ADDENDUM

04

Lancaster Township Police Department Renovations & Addition Lancaster, PA Date of Addendum: 18 September, 2024

Marotta/Main Architects Project No.: 24-LT-01

LOWER AND UPPER
LEVEL DEMOLITION
FLOOR PLANS
SHEET NUMBER:

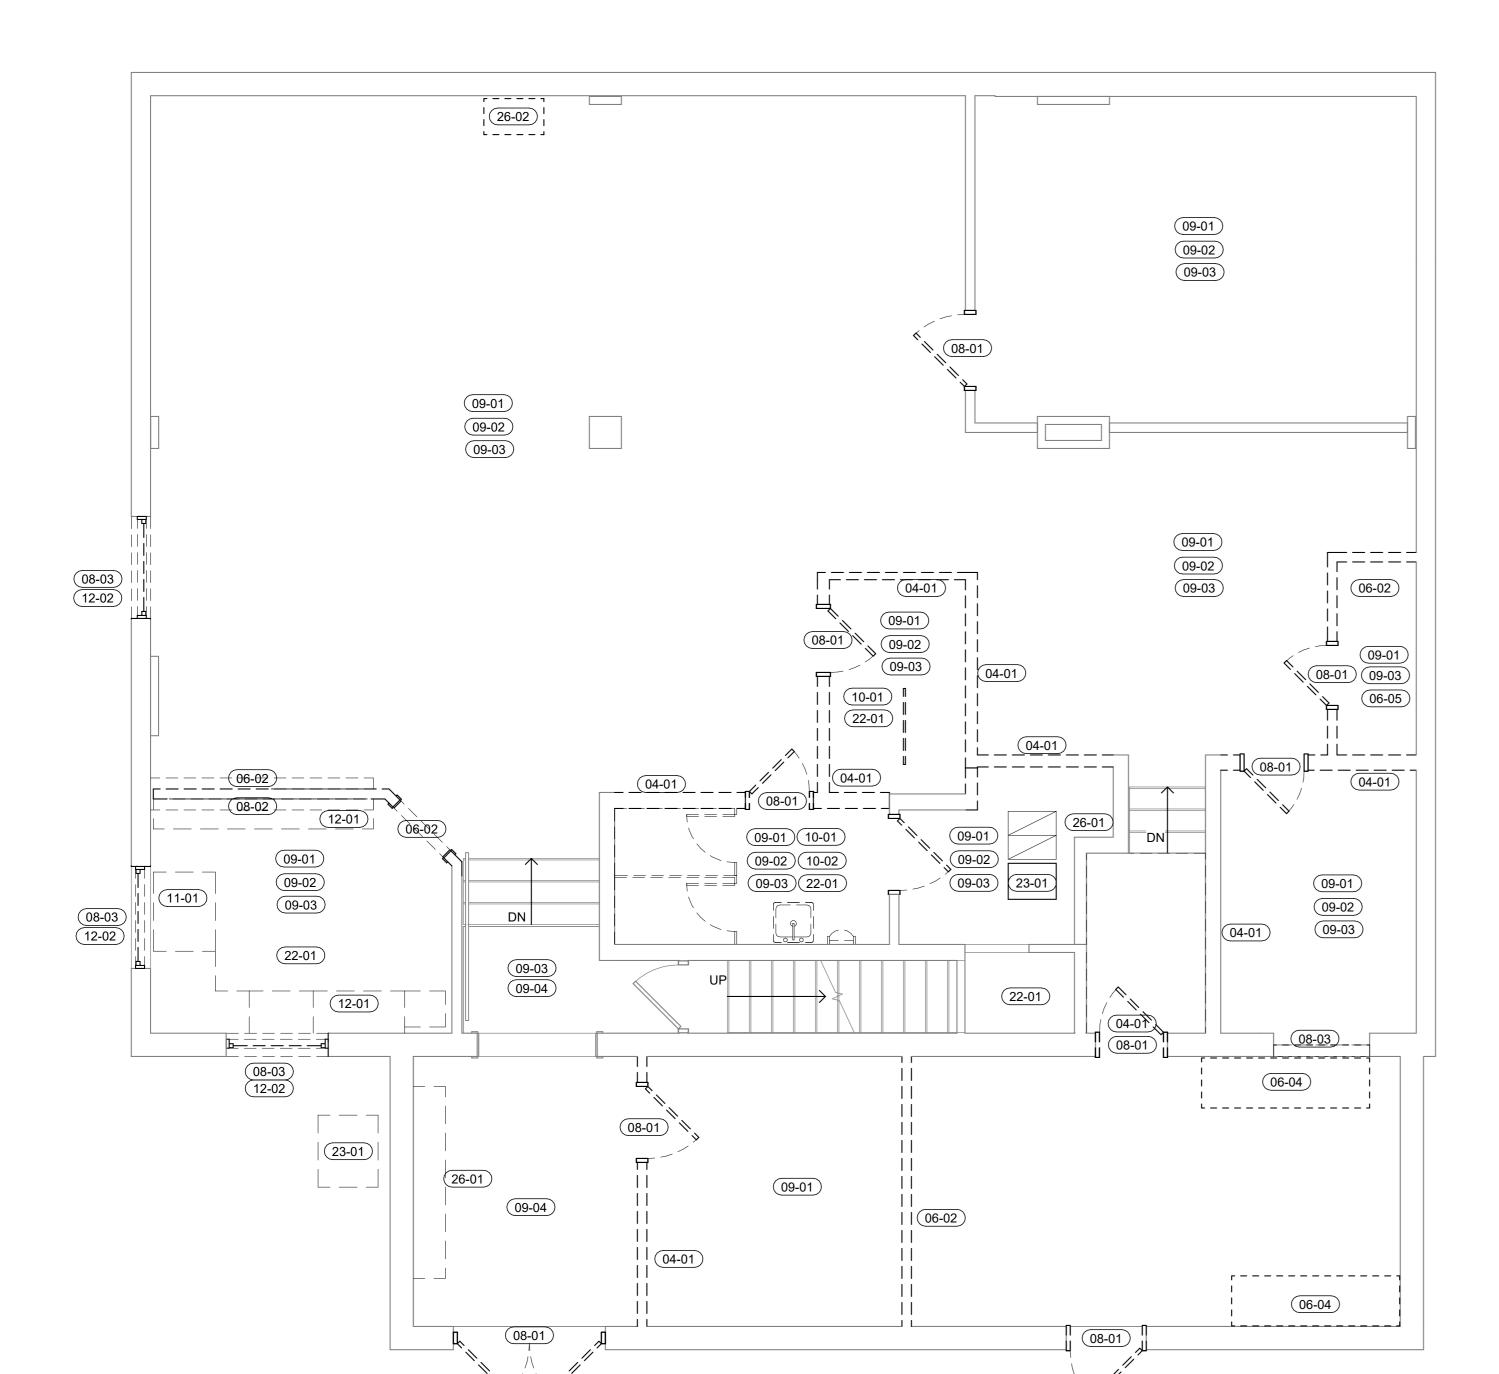
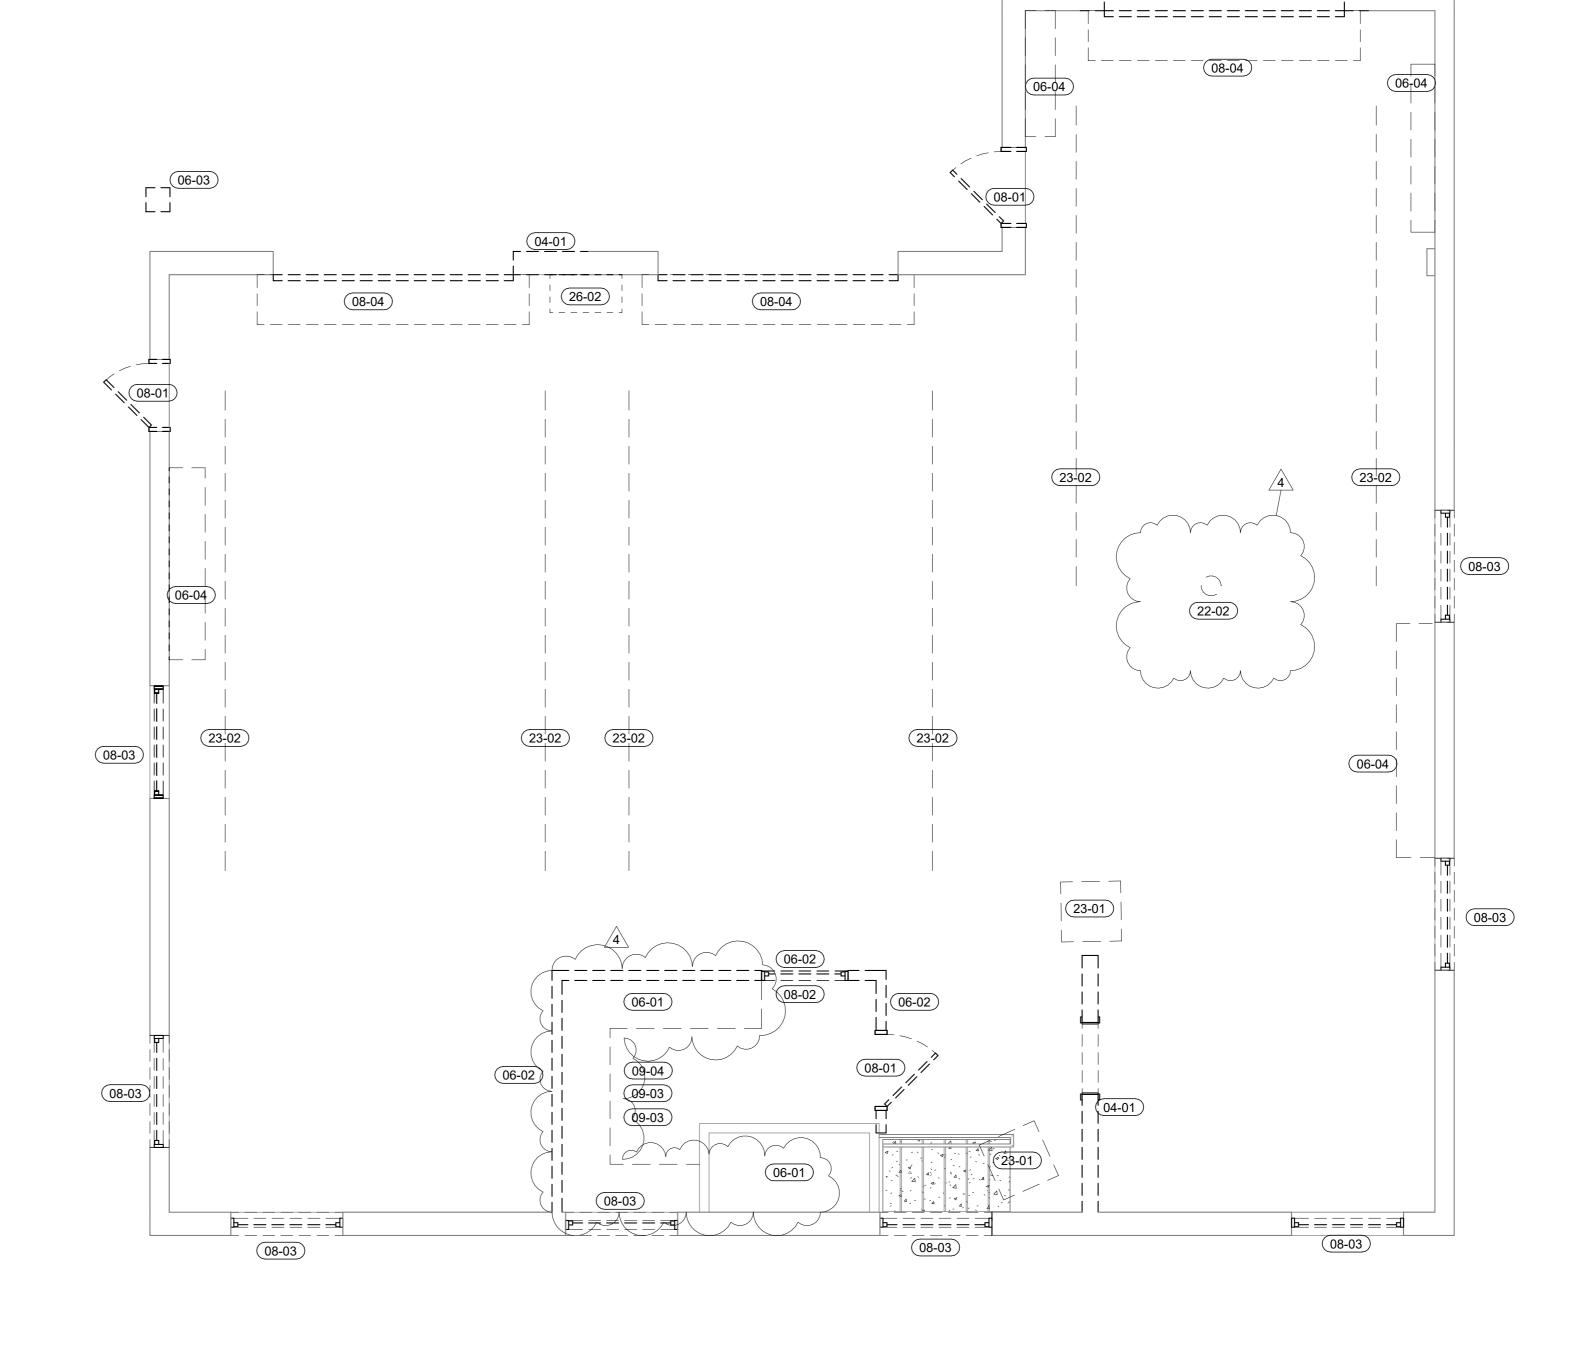
- 04.10 Refer to Drawing AD1.1 LOWER AND UPPER LEVEL DEMOLITINO FLOOR PLANS attached with clouded revisions.
- 04.11 Refer to Drawing A1.2 LOWER AND UPPER LEVEL FLOOR PLANS attached for clouded revisions.
